BLYTHE ENERGY PROJECT

**Request for Approval of Third
Insignificant Project Change
(99-AFC-8C)**

**Blythe Energy Project
Transmission Line
Minor Structural Changes, Additional Communications
Systems, and Expanded Work Areas**

November 2008

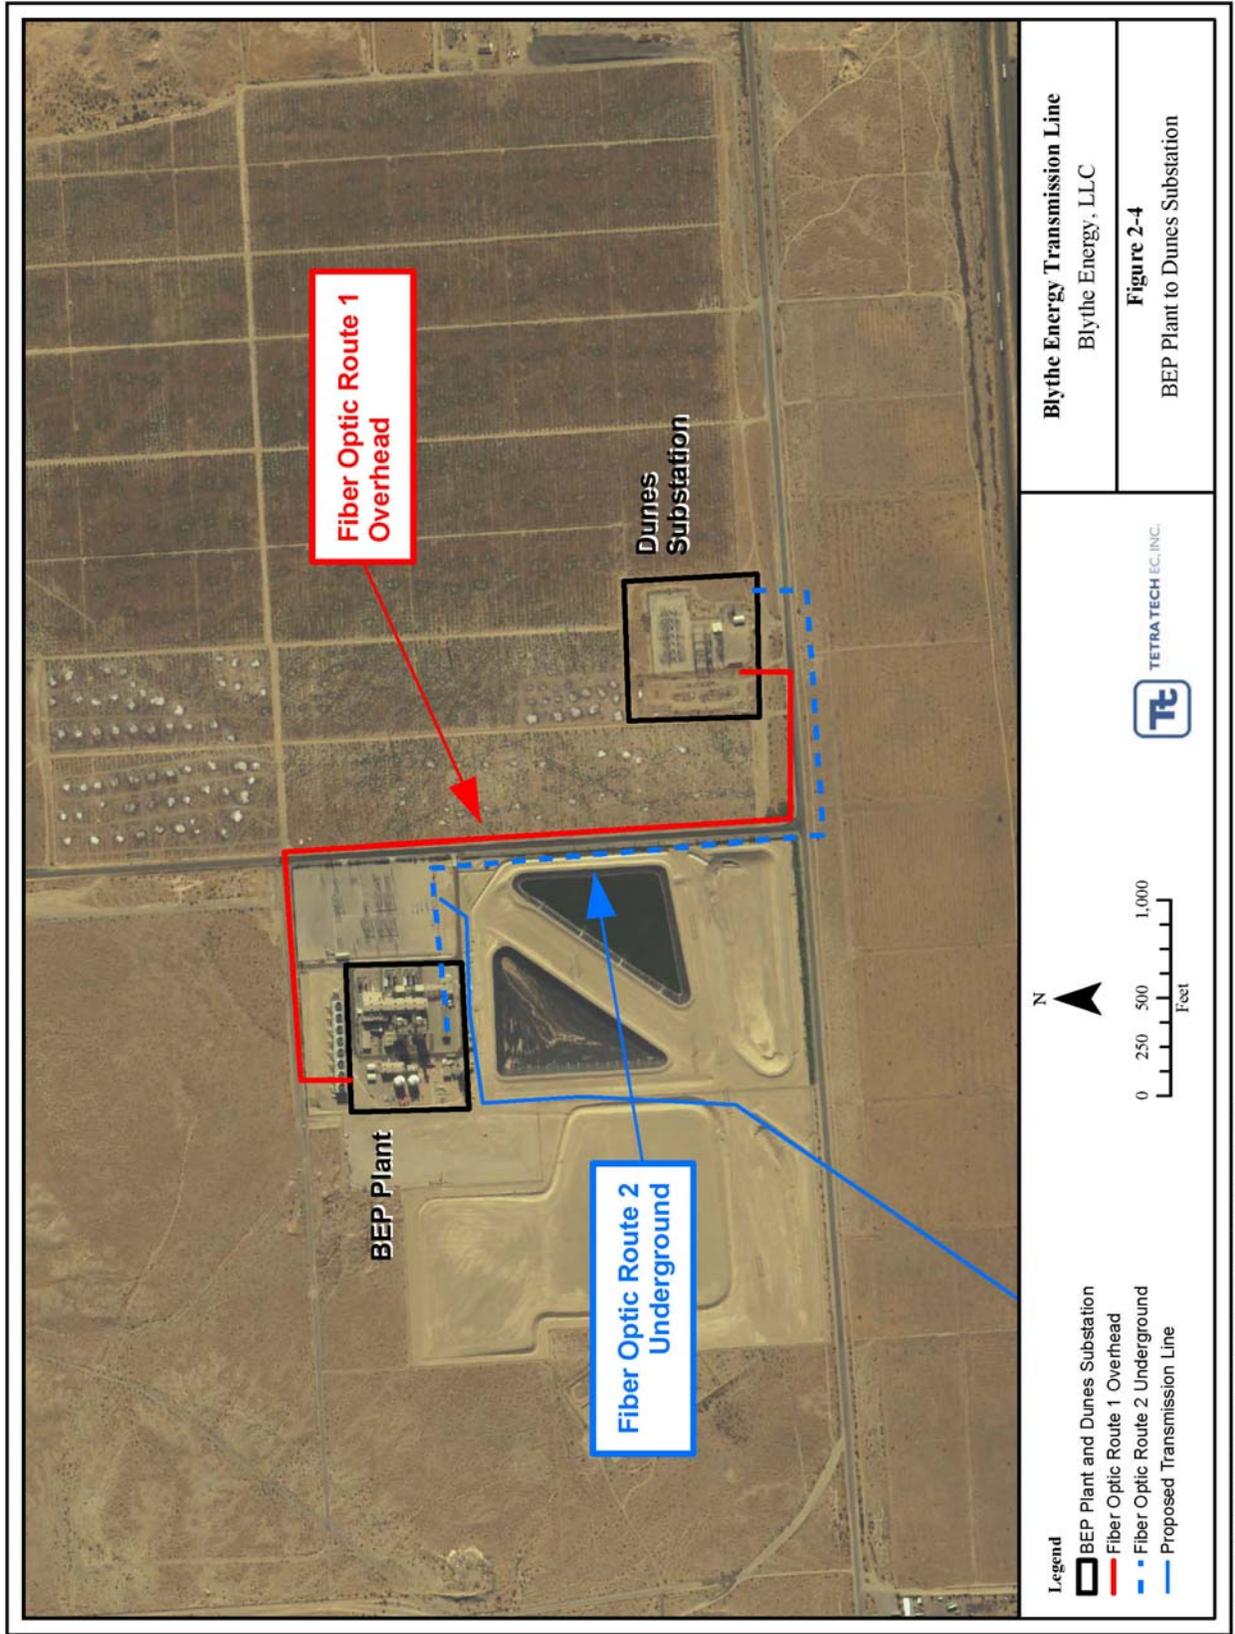
Figure 2-4 illustrates the proposed fiber optic cable routes from the BEP to the Dunes Substation. In addition to the dual fiber optic cable installation, Edison Network Services Engineering (Edison) will require space within a building that will be constructed as part of the improvements within the BEP to accommodate the changed routing of the power. The westernmost cable (FO-2) will travel in an underground conduit installed adjacent to the existing BEP paved entryway, then turn south at the edge of the Buck Boulevard ROW to the Hobson Way ROW. This cable in conduit will be installed with a directional drill underneath Hobson Way, will emerge within the Hobson Way ROW on the south side of the road, and will then turn east and proceed along Hobson Way within and at the edge of the road ROW. It will turn north again under Hobson Way through the use of a directional drill and emerge immediately adjacent to the southeastern corner of the Edison Dunes Substation.

SCE Telecom will construct the easternmost cable (FO-1), overhead for about 5,300 feet on new and existing poles, and for approximately 900 feet in underground conduit. The cable will leave Dunes Substation overhead heading due south to Hobson Way. It will continue west along Hobson Way, along the north side of the road, to Buck Boulevard. It will head north along the east side of Buck Boulevard. At Riverside Avenue it will turn west and cross Buck Boulevard and run along the south side of Riverside Avenue to the west side of the Blythe Energy Plant. It will then come down on a riser pole to continue underground to the south, into the Blythe Energy Plant.

Edison stated that the BEP-Dunes Fiber Optic Path is needed to provide a link to the existing SCE Telecommunications network to meet SCE’s protective relaying requirements. Edison has therefore concluded that a new optical information system station is required at the BEP to provide needed communications and control, and that a fiber optic path is needed to existing communication equipment found in Edison’s Dunes Substation. The fiber optic path needs a redundant component to provide for the unlikely event that one of the fiber optic paths is interrupted and to guarantee communication between the BEP and the Edison portion of the Southern California grid.

R:\projects_2005\fp_blythe_line\maps\insignificantChangeReport3_1108\Figure 2-5.mxd
11/20/2008

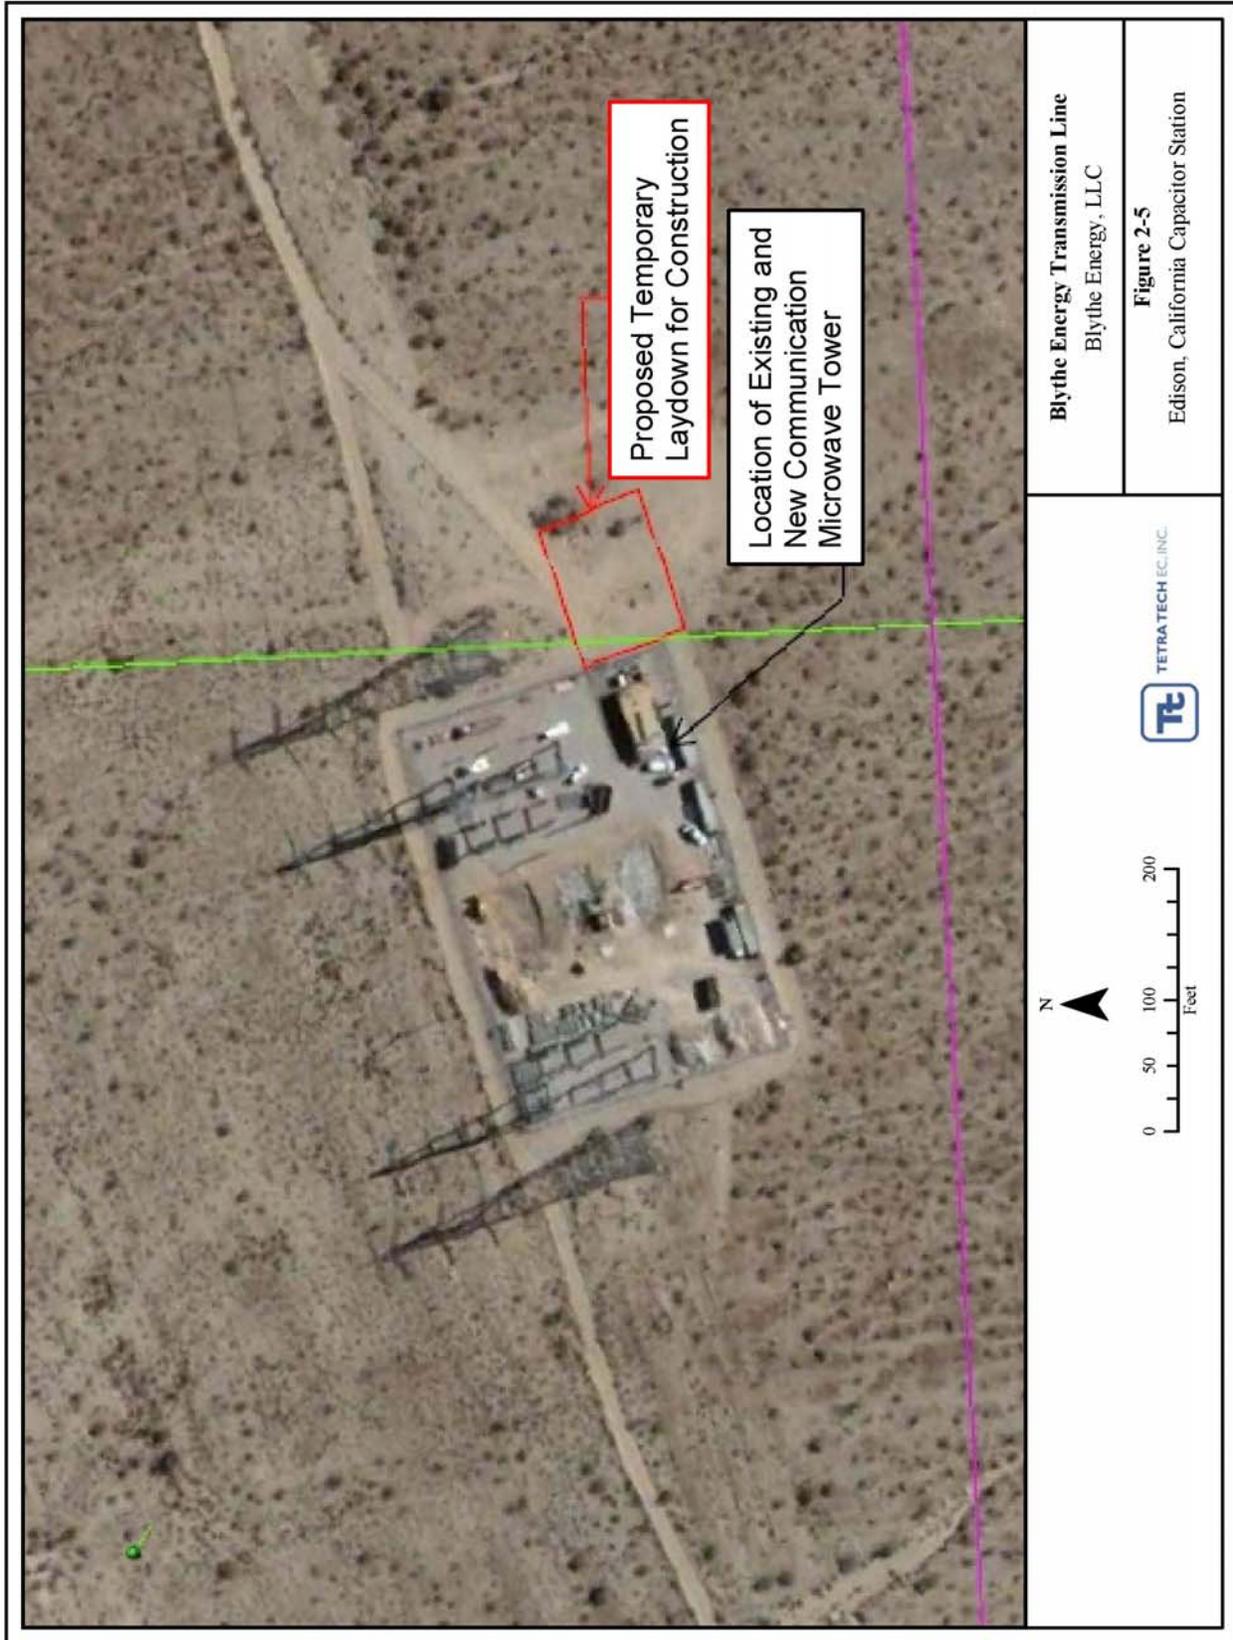
Figure 2-5 and 2-6 illustrate the location of the requested change of microwave tower at the Edison-owned California Capacitor Station (CalCap). The CalCap is located just south of I-10 at the Red Cloud Road exit. The nearest BEPTL structures are 369 and 370. There is an existing unsurfaced road that accesses the CalCap, which is located on public land administered by the BLM in Township 6S, R14E, SW ¼ of the SE ¼ of Section 6, San Bernardino Base & Meridian. The CalCap is a permitted use of public lands under case file #CA4163. Edison will request an amendment to their ROW Grant to accommodate the proposed tower change.

The changes needed at the CalCap, though occurring within the Chuckwalla Desert Wildlife Management Area, do not include any new disturbance. As shown on the aerial photograph in Figure 2-5, all construction will occur within a graveled fenced area and the temporary laydown area has been previously used, is used presently for parking by personnel servicing the CalCap, and is devoid of vegetation.

Figure 2-6. Edison Proposed 120-Foot Communication Tower

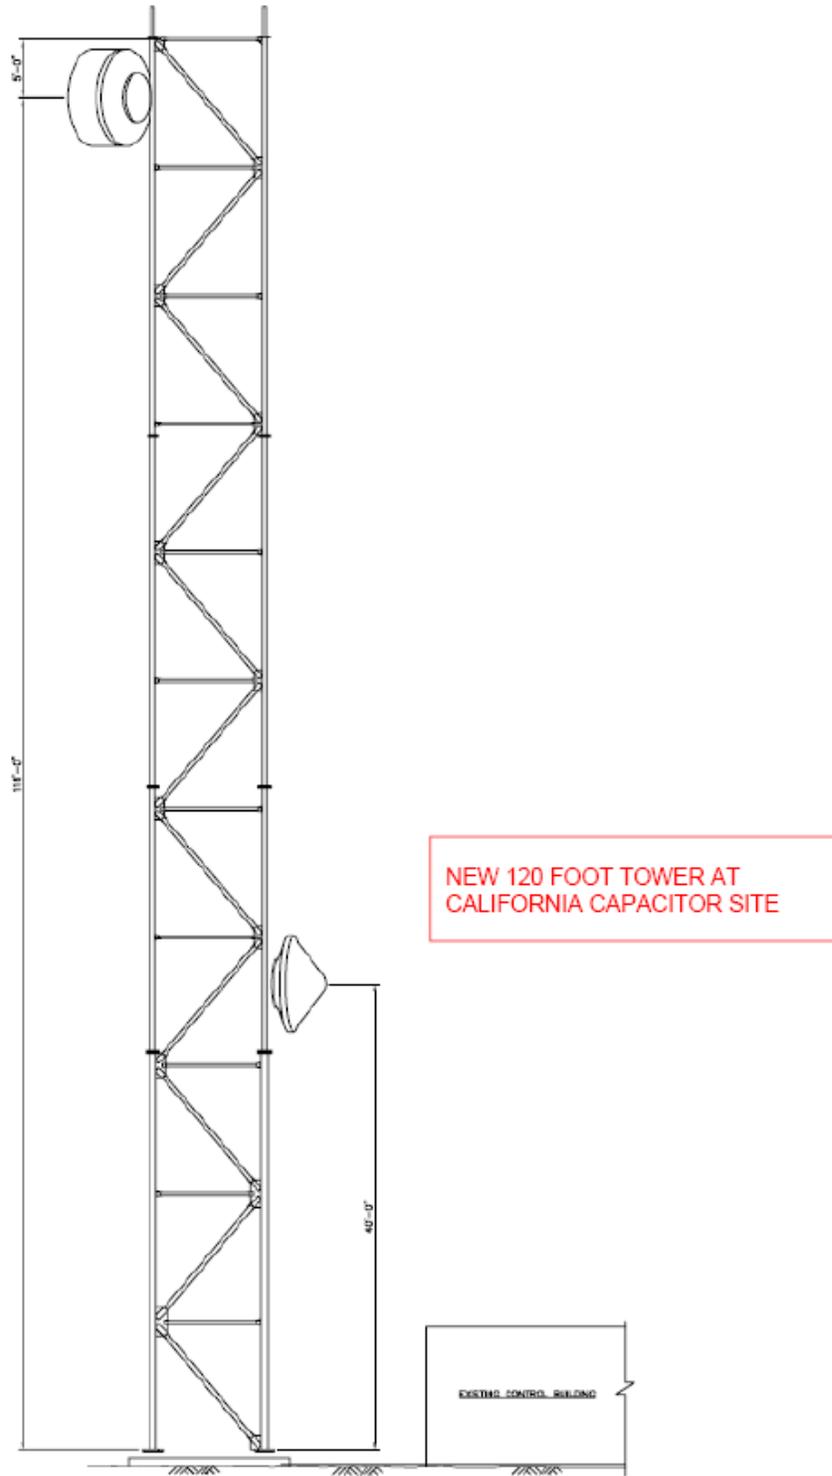
Edison will replace an existing 20-foot microwave tower with a new 120-foot tower (Figure 2-6) just west of the Mechanical Electrical Equipment Room (MEER) inside the existing fence line of the CalCap.

Edison stated that the new tower is needed to provide a diverse communications link from the SCE Telecommunication network to Julian Hinds, to meet SCE’s protective relaying requirements. The tower is planned at 120 feet in height to clear the 500-kV switch rack at California Capacitor.

The addition of the 120-foot CalCap communication tower to provide communication security between Julian Hinds and Blythe and to provide control over BEP production will replace the existing smaller tower to clear the 500-kV switch rack at the CalCap station. The proposed modification will blend in with the surrounding 500-kV transmission towers at the CalCap station and will not be detectable from observer distances. Therefore, visual impacts resulting from these changes will be insignificant.
